# METROPOLITAN GOVERNMENT OF NASHVILLE AND DAVIDSON COUNTY

## STAFF RECOMMENDATION 1115 Greenwood Avenue August 15, 2018

**Application:** New Construction—Outbuilding; Setback Determination  
**District:** Eastwood Neighborhood Conservation Zoning Overlay  
**Council District:** 06  
**Map and Parcel Number:** 08301046400  
**Applicant:** John Pirtle  
**Project Lead:** Melissa Sajid, [melissa.sajid@nashville.gov](mailto:melissa.sajid@nashville.gov)

**Description of Project:** Application is to construct an outbuilding and includes a setback determination to reduce the right side setback from ten feet (10') to eight feet, six inches (8'-6").

Figures 1 and 2: 1115 Greenwood Avenue from Greenwood Avenue (left) and North 12<sup>th</sup> Street (right)

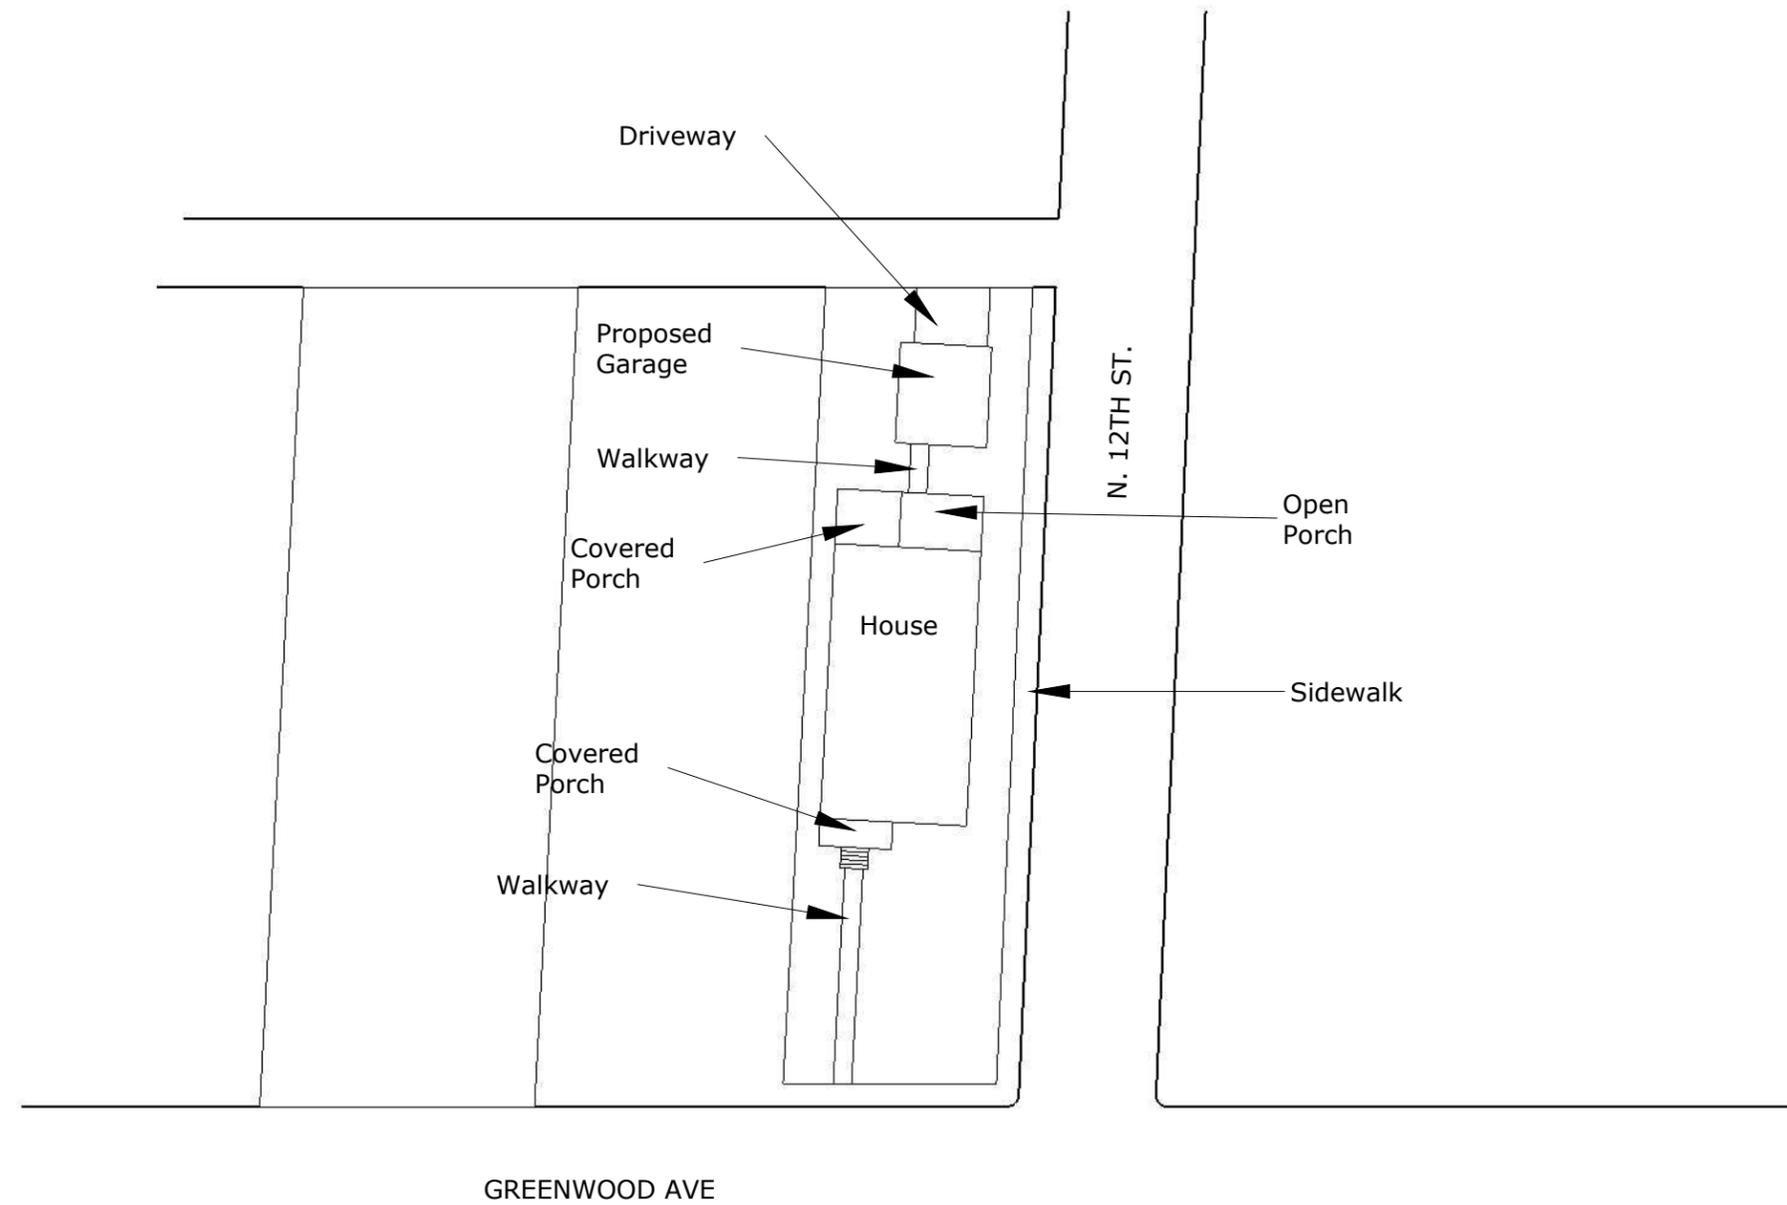
**Background:** The infill at 1115 Greenwood Avenue was approved by the Commission in October 2016 and is currently under construction (Figures 1 and 2). 1115 Greenwood is a corner lot.

GARAGE SITEPLAN

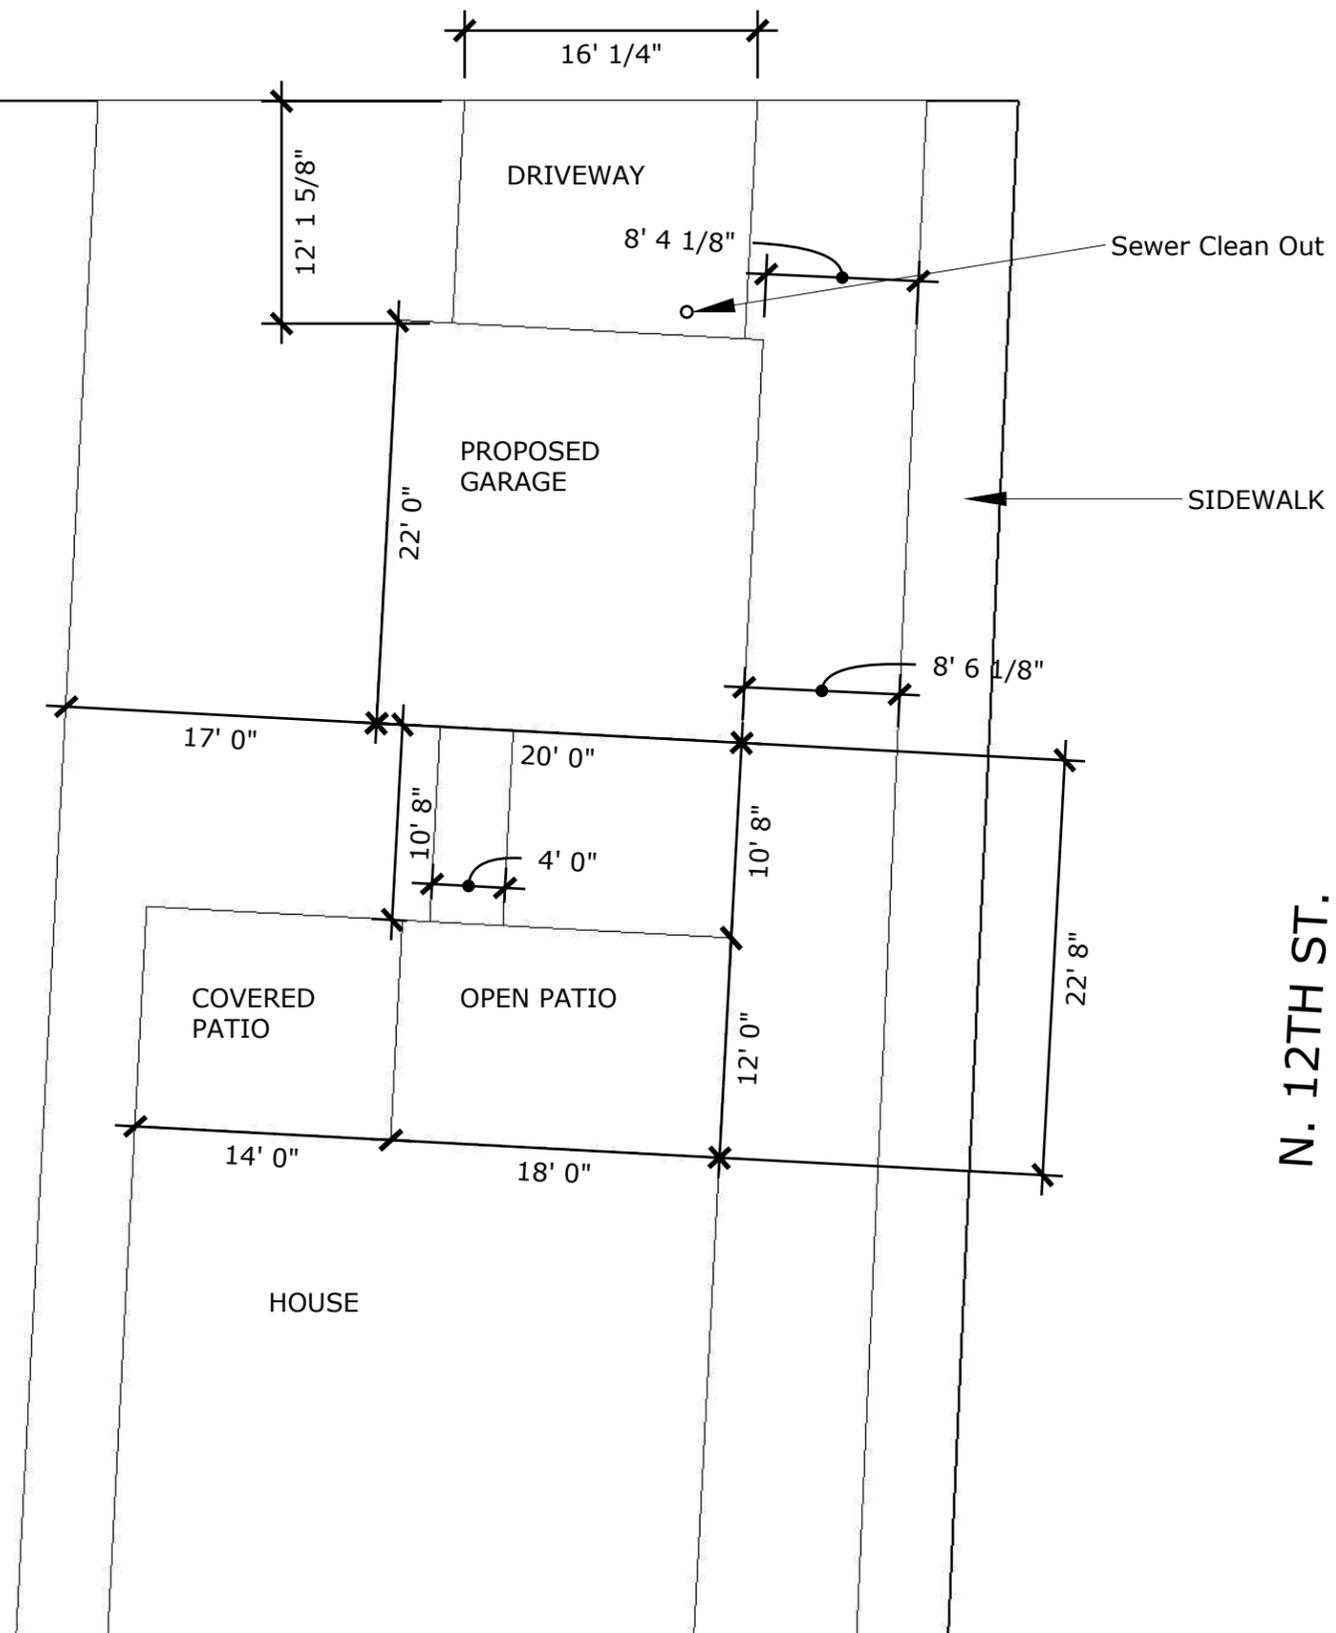
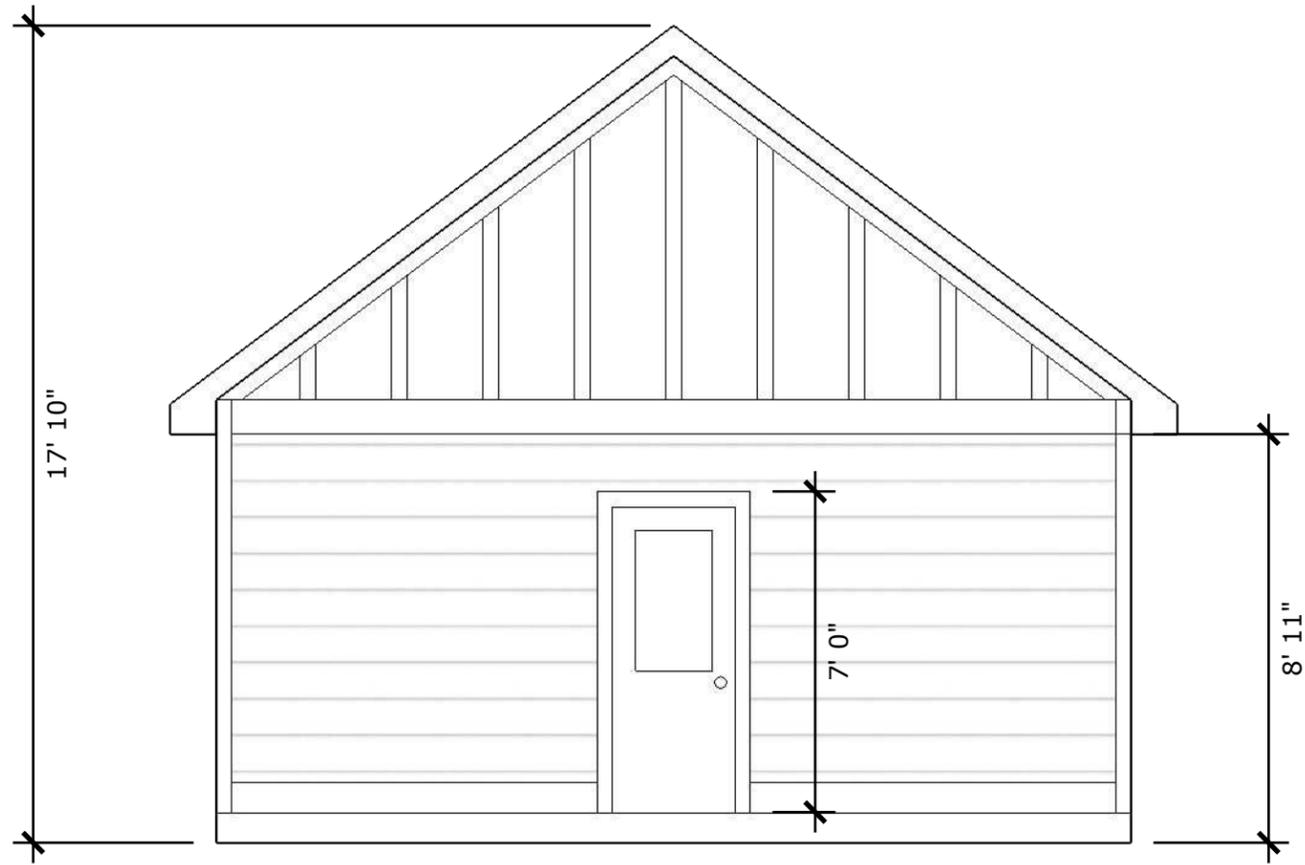
**Analysis and Findings:** Application is to construct a single story outbuilding and includes a request to reduce the right street-side setback from ten feet (10’) required for corner lots to approximately eight feet, six inches (8’-6”).

The rear and left side setbacks meet the design guidelines and zoning requirements. The applicant has requested a setback determination to reduce the right street-side setback along North 12<sup>th</sup> Street from ten feet (10') to approximately eight feet, six inches (8'-6"). The Commission approved a setback determination in 2016 for the recently constructed infill, and the proposed outbuilding will be no closer to North 12<sup>th</sup> Street than the house. Therefore, staff finds that the requested setback determination could be appropriate in this case.

The proposed outbuilding is to be located ten feet, eight inches from the covered patio at the rear of the house. A minimum separation of twenty feet (20') is required by the design guidelines. Staff finds that a reduced separation could be appropriate in this case given the deep front setback on the lot, the small size of the outbuilding, and the fact that the proposed outbuilding is only one-story. Staff finds that the site planning and setbacks meet Section II.B.h.2 of the design guidelines.

FRONT ELEVATION

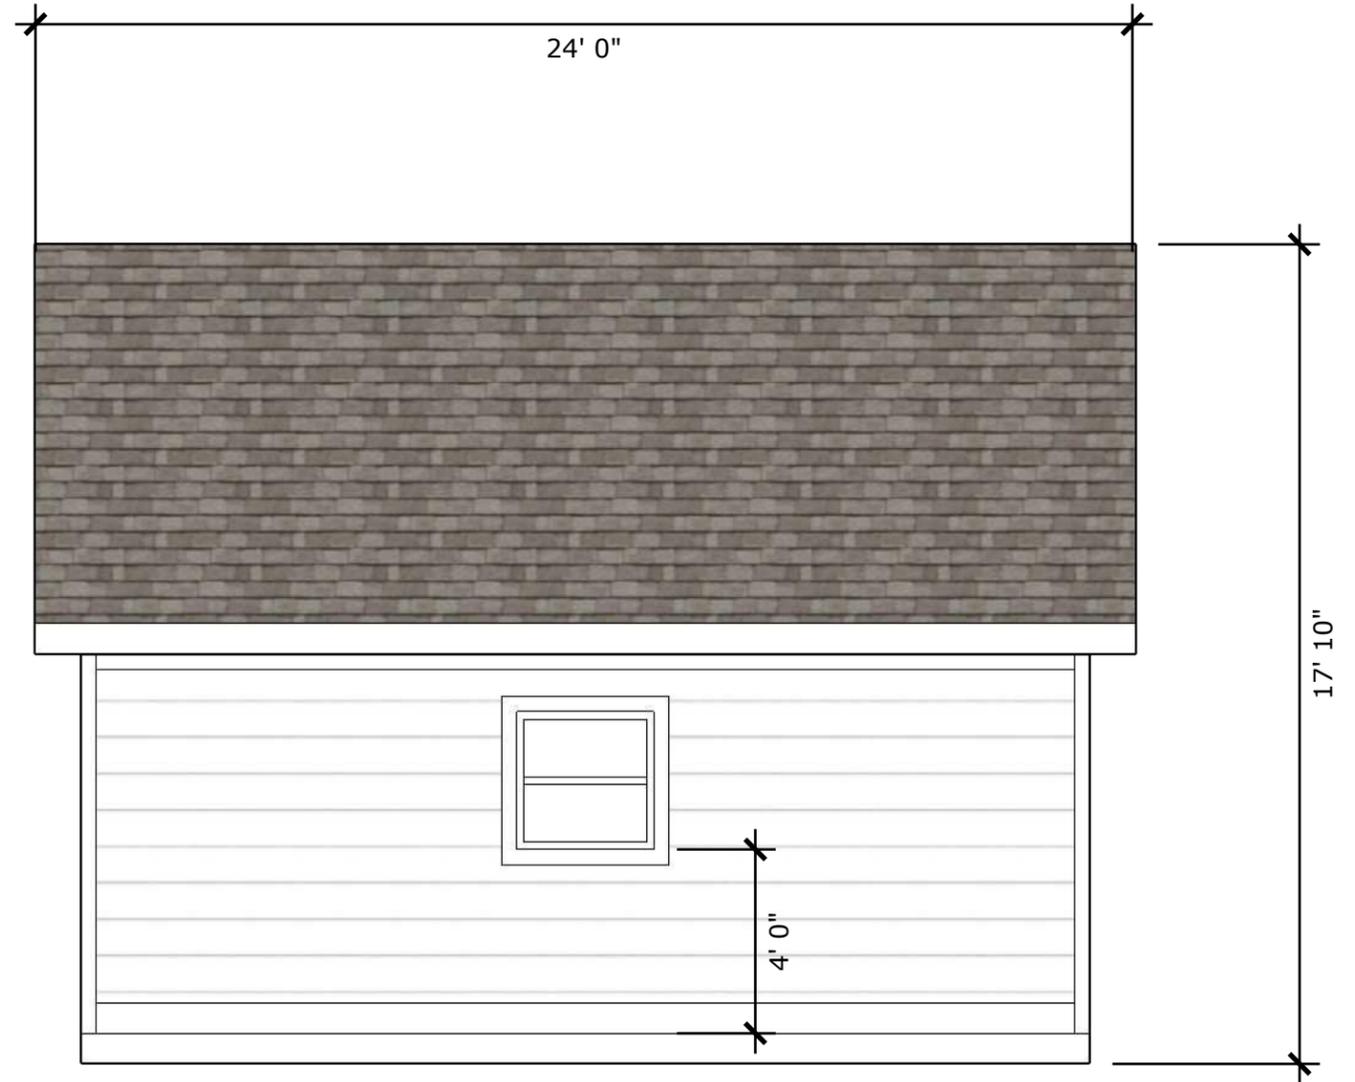
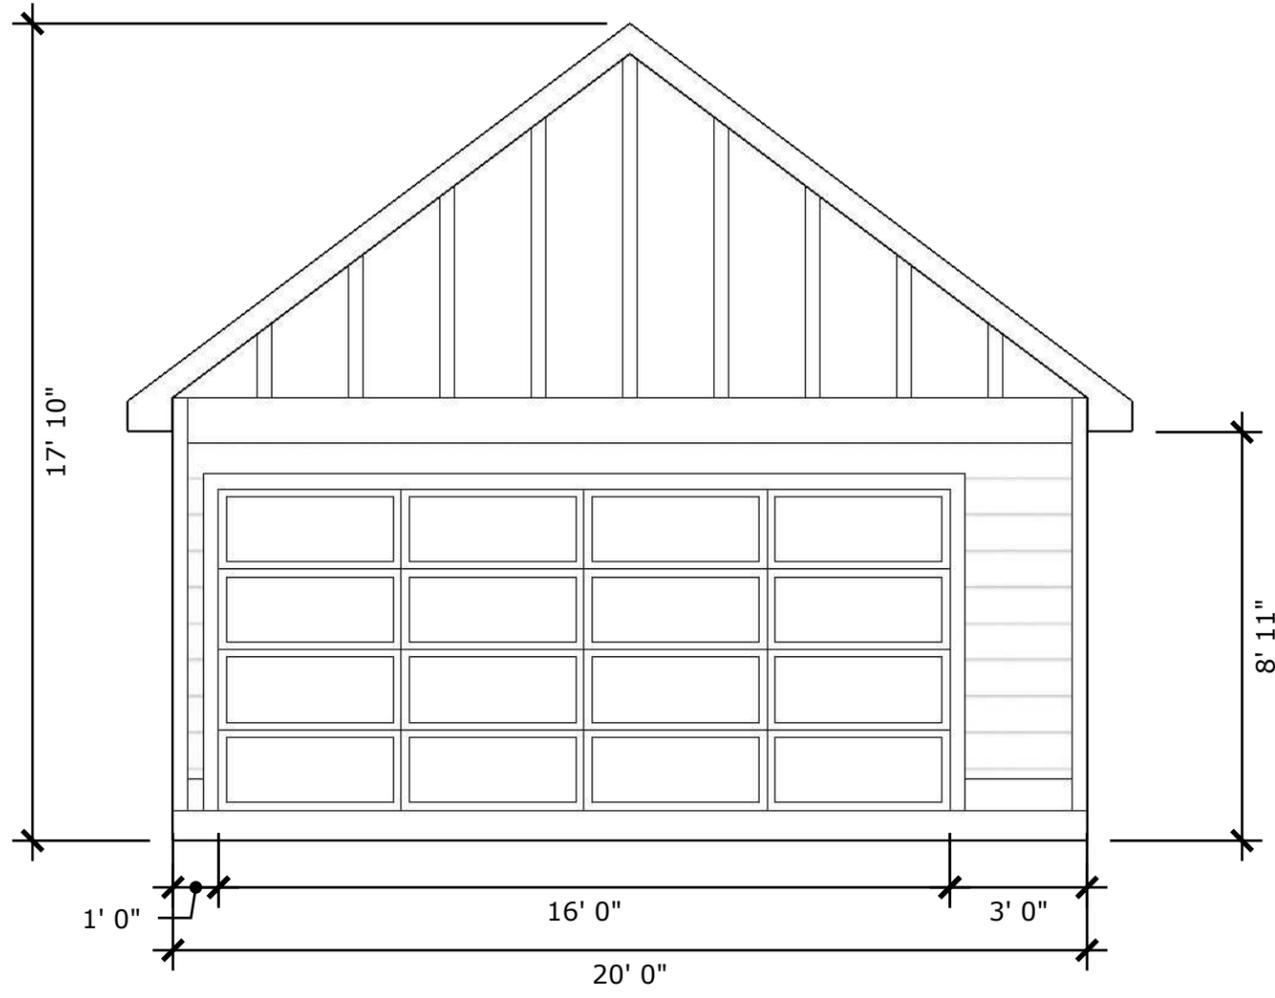
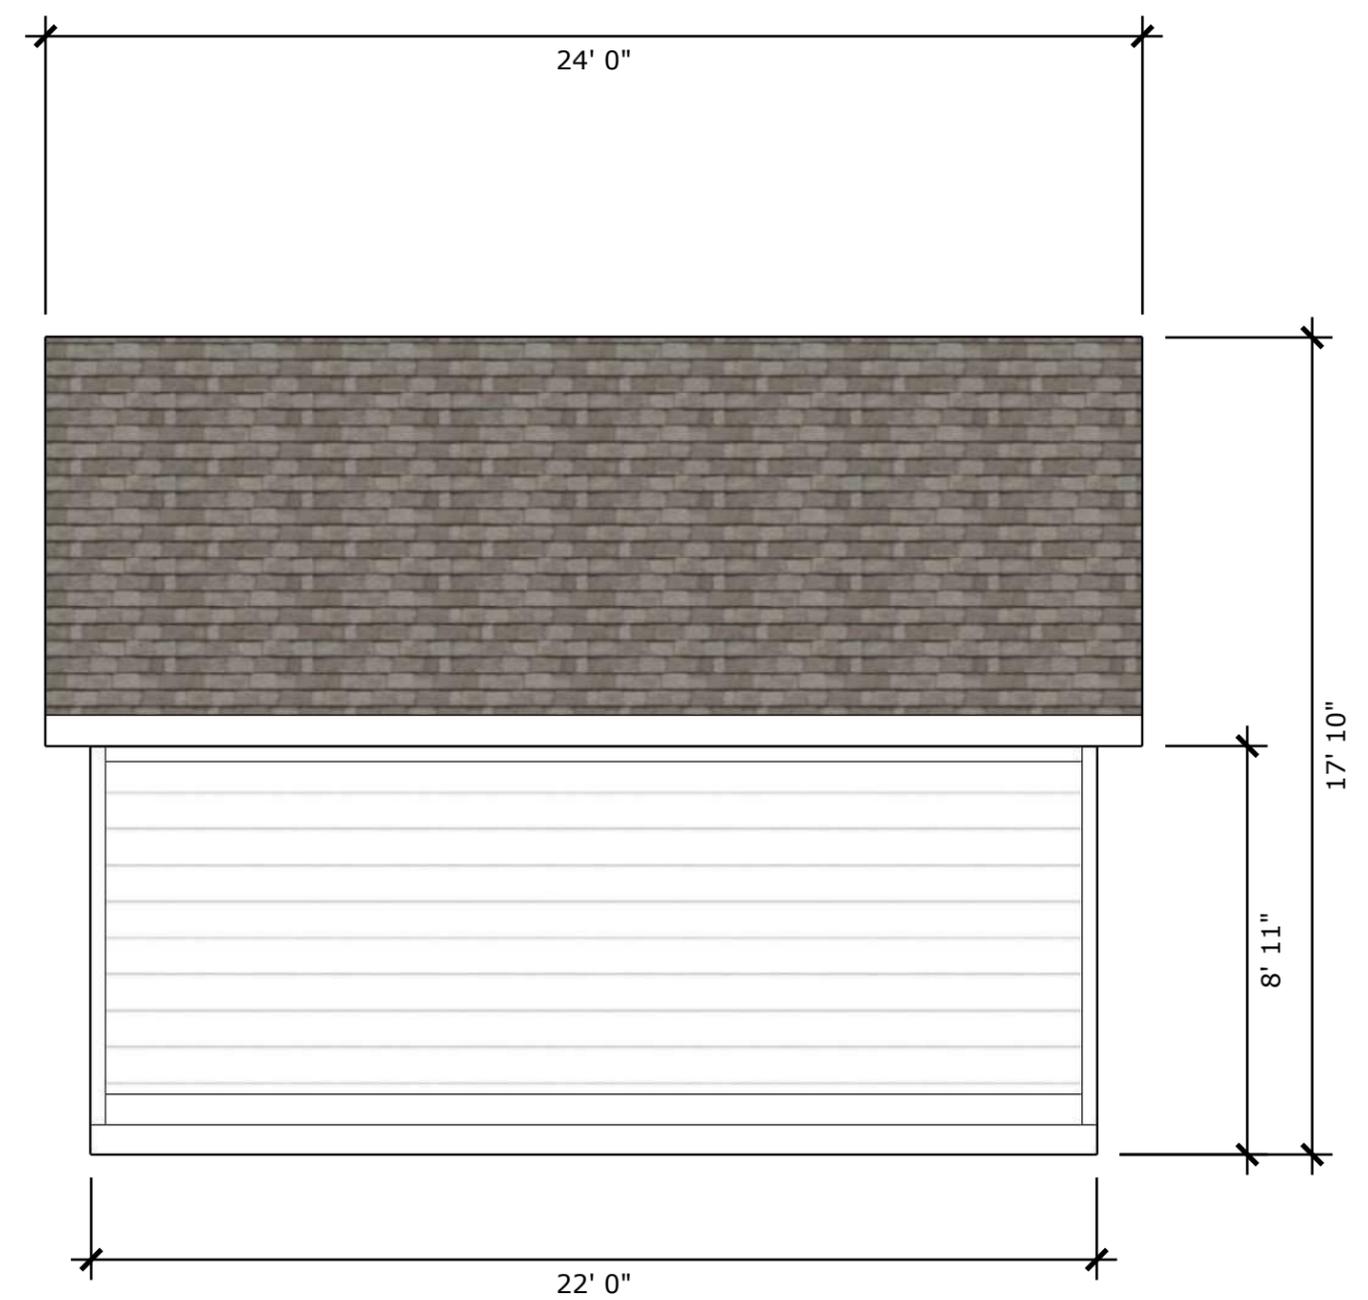
Design Standards: The materials of the outbuilding will be similar to the house while the proportions and overall character will be more utilitarian. Its front gabled roof form reflects the rear gable on the house, and the materials are the same as the materials used for the primary structure. The window proportions and locations are compatible with those of outbuildings historically. Staff finds the design of the proposed outbuilding to meet section II.B.h.1 of the design guidelines

The outbuilding will be clad in fiber-cement siding, but the texture and reveal were not noted. Staff recommends a condition that the siding and trim be smooth faced and that the siding have a maximum reveal of five inches (5"). With this condition as well as the condition that the final roof color, window, door, and garage door selections are approved by MHZC Staff prior to purchase and installation, the project will meet section II.B.h.1 of the design guidelines.

1. Staff approve the final material selections of the roof color, window, door, and garage door prior to purchase and installation; and,
2. The siding and trim shall be smooth faced, and the siding shall have a maximum reveal of five inches (5").
